APPENDIX 7: RECOMMENDED CONDITION TABLE

CRC192408 & CRC192409 Land use consent to excavate material and deposit cleanfill material over an unconfined/semi-confined aquifer	
Applicant's proposed conditions	Reporting Officer comments and recommendation
Description	
<p>1) <i>The use of land for the construction works associated with development of the quarry, extraction of overburden and aggregate material, stockpiling of extracted aggregate, the deposition of cleanfill, and remediation of completed quarrying areas shall be at located on the land between Curraghs, Dawsons, Maddisons and Jones Road, legally described as Rural Section 6475 and Rural Section 6324, Lot 1 Deposited Plan 4031, Rural Section 6342, Section 7 Survey Office Plan 510345, Rural Section 5381 and Section 6 Survey Office Plan 510345, at or about map reference NZMS 260 M26:6505-3830, shown as the area inside the Site boundary in red on the Site Location Plan prepared by Golder Associates, dated November 2018, which forms part of this consent.</i></p>	<p>I recommend this condition could be simplified to list the activities which are authorised by CRC192408 and CRC192409 and refer to a plan depicting the site instead

Figure 1: Three-part diagram showing quarrying staging.

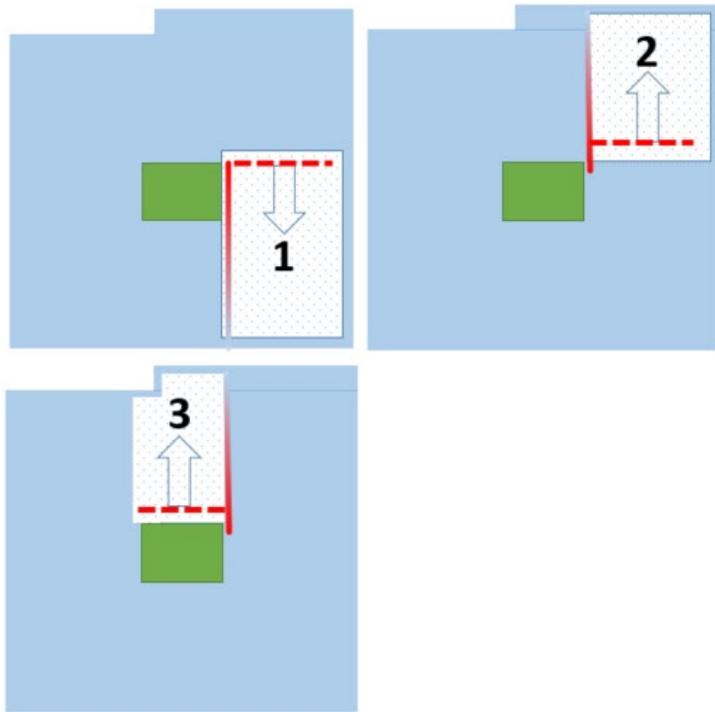
<p>11) <i>The Consent Holder shall survey all excavated and filled areas of the site annually to determine the elevations of the site relative to datum established under condition (7)), including the depth of excavation. The survey shall be undertaken by a registered surveyor. The survey result shall be to an accuracy of +/- 50 millimetres vertically. The results of such survey shall be provided to the Manager, annually and otherwise on request.</i></p>	<p>I consider this proposed condition (11) is a duplicate of proposed condition (4). I recommend proposed condition (11) should be deleted.</p>
<p>Excavation of Aggregate</p>	
<p>12) <i>Excavation of aggregates shall commence with extraction in the centre of the site (adjacent to the central processing area shown in green) and shall occur in a progressive sequence (moving southward and then anticlockwise) generally in accordance with the three-part diagram in Figure 1 below. Full staging beyond Stage 3 shall be provided to the Manager at least one month prior to Stage 4 commencing. Excavation of aggregates shall occur from the quarry floor, once the pit is established.</i></p>	<p>I agree that a condition should be included which specifies proposed quarry staging. I consider the wording of this condition could be improved to clarify how staging will be undertaken and the diagram needs to be amended to show the 100 metre exclusion areas for 319 Maddisons Road and 153 Curraghs Road. I recommend Figure 1 should be amended and included as a Plan appended to this resource consent.</p>
